<b>Docket Number:</b>	17-AAER-07
<b>Project Title:</b>	General Service Lamps
<b>TN #:</b>	224611
<b>Document Title:</b>	Presentation - NRDC Comments on CEC Draft Staff Report - Analysis of General Service Lamps (Expanded Scope)
<b>Description:</b>	By Noah Horowitz - The Importance of Updating the Scope of California's Light Bulb Regulations
<b>Filer:</b>	Patrick Saxton
<b>Organization:</b>	National Resources Defense Council
<b>Submitter Role:</b>	Public
<b>Submission Date:</b>	8/28/2018 6:28:36 AM
<b>Docketed Date:</b>	8/28/2018

# THE IMPORTANCE OF UPDATING THE SCOPE OF CALIFORNIA'S LIGHT BULB REGULATIONS

# CA low lumen lamp regulation needed to cover bulbs like this that are under the federal 310 lumen cutoff

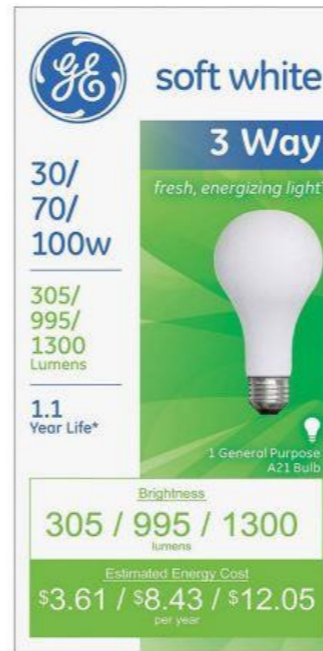
- 40 watt incandescent bulb
- Produces 265 lumens of light
- Average life of 2,250 hours
- Pack Size: 3 bulbs
- › See more product details
